## **B-R) Remarks to the specifications amendments**

**November 22, 2003 10/038,459**

**Annotated Marked-up Drawings: 11-22-2003 10/038,459**

**Fig. 1(c)**

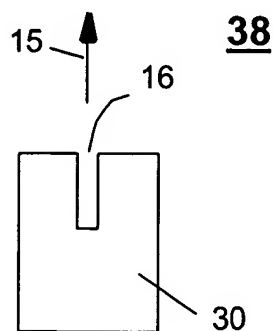
**“Fig. 1(c) shows a prior art waveguide probe (38) with a main probe body (30) and a slot (16). The slot has an axis (15) for connection to the first part (7) of central metal pin (2). According to the prior art structure, the electric field or E-field (39’) of the microwave signals (39) will be perpendicular to the broad side walls (32,33) or parallel to broad walls (20b) defining a reference plane as depicted in Fig. 3(a).” has been added after “--- signals (39) to be propagated.” To describe the features of the waveguide probe. [examiners’ Remark No. 4 ]**

**Fig. 3(a)**

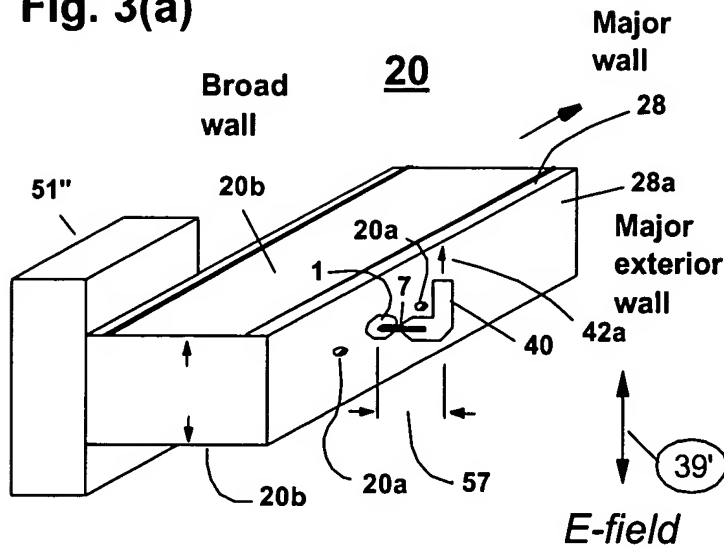
**“as shown in Fig. 3(a)” has been added after “conductive housing” {Remark 2]**

Fig. 3(a): numeral “39” has been added to indicate the E-field. The horizontal arrow has been deleted to clarify the E-field. [Remark 1]

**Fig. 3(b)**

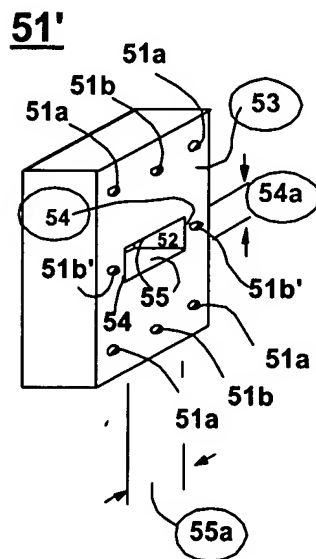
Fig. 3(b): numerals “52”, “53”, “54”, “54a”, “55a” and arrows have been added to clarify key features. [Remark 5]

**Fig. 3(d)**

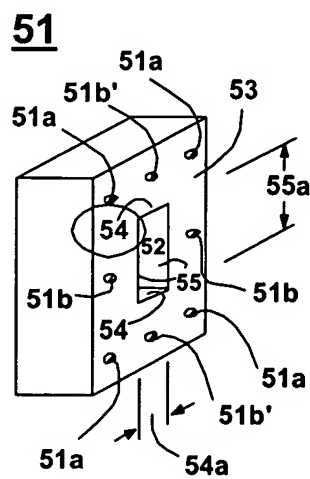
**“(51) as shown in Fig. 3(d)” has been inserted between “The universal launcher adapter” and “is constructed by metals --. , alloys or plastic materials with layers of metals coated on all walls. A through channel (52) is arranged “region” has been inserted between “-- in the center” and “of the broad wall (53).” [Remark 3]**

Fig. 3(d): numeral “54” and a guide line have been added [Remark 5]

**Fig. 3(c)**

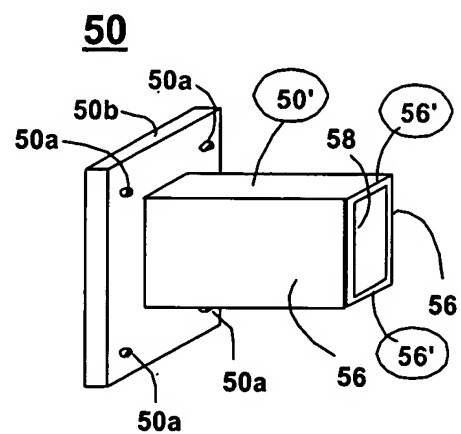
Fig. 3(c): numeral “50’ ”, and 56’ “ have been added. [Remark 5]

Fig. 4(c)

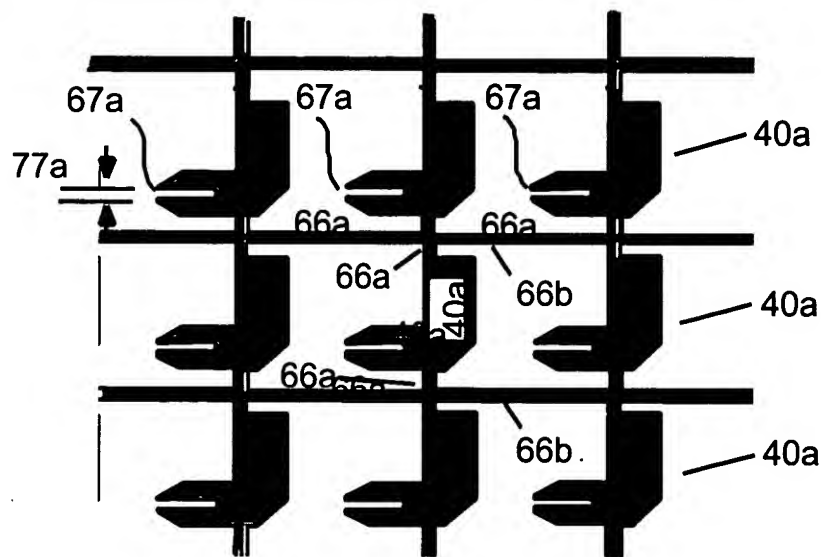
Fig. 4©: numerals “69” have been replaced by “40a” [Remark 4]

New sentences **“Each of the L-shape waveguide probes (40) formed is covered by a photoresist pattern (40a). It is noted that due to the etching, there is an edge recess or undercutting (U) in the peripheral regions for each waveguide probes (40).” have been added to replace “**~~Here, L-shape waveguide probes (40) are created by the etching.~~**”** to describe undercutting and features shown in Fig. 4. [Remark 4]
